SERVICE BULLETIN: JSB 031-2

Subject: Jabiru Engine Through Bolts

Affected Models: Jabiru 2200 and 3300 Engines

SAFETY DIRECTIVE: JSD 031-2

Figure 1 – General Engine Layout

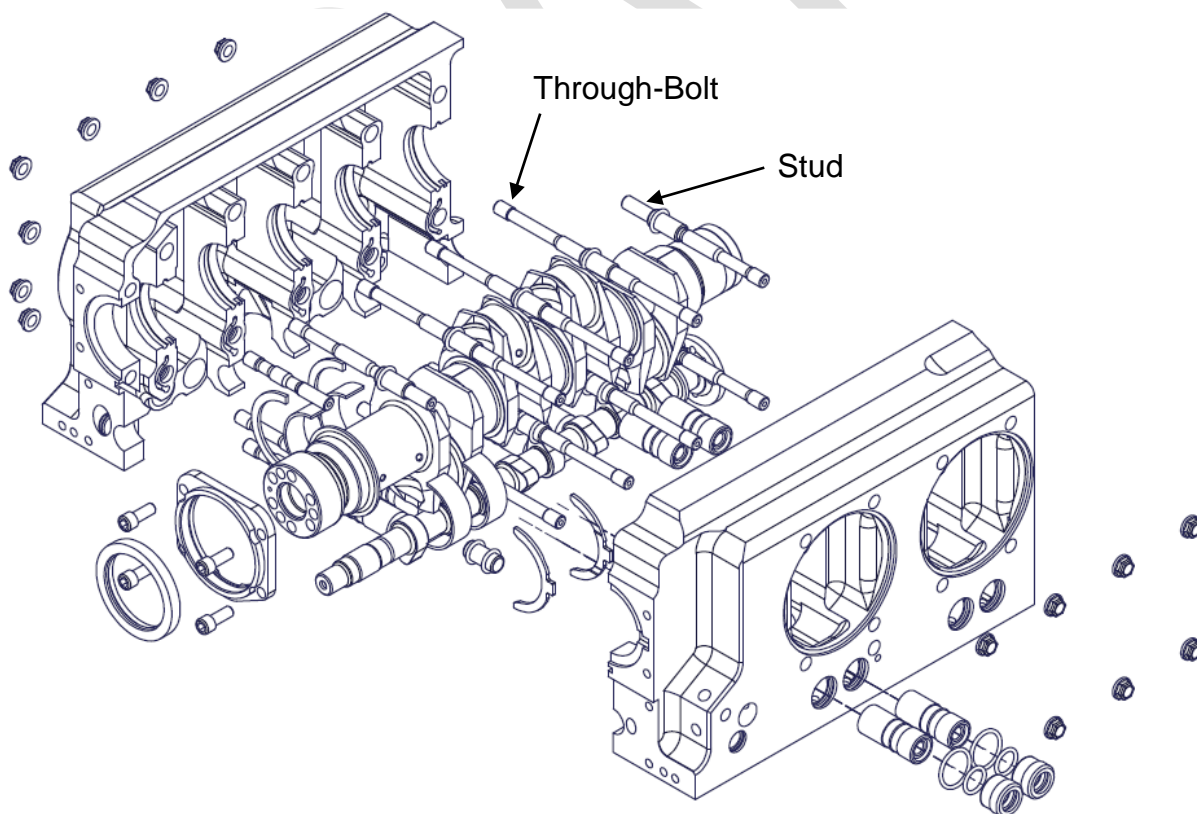
- Jabiru Engines are assembled using a combination of Through-Bolts and Studs – as shown in Figure 1 below. The number of through-bolts varies depending on which engine model is considered but there are always 6 studs (not all with the same part number). The through-bolts and studs hold the cylinders in place and the halves of the crankcases together.

- There have been some cases of these bolts failing in service, leading to engine failure.
- In April 2011 JSB031 Issue 1 was issued. This bulletin detailed then-current inspections and alterations required to correct this potential unsafe condition with the through-bolt hardware of certain Jabiru 2200 and 3300 engines.
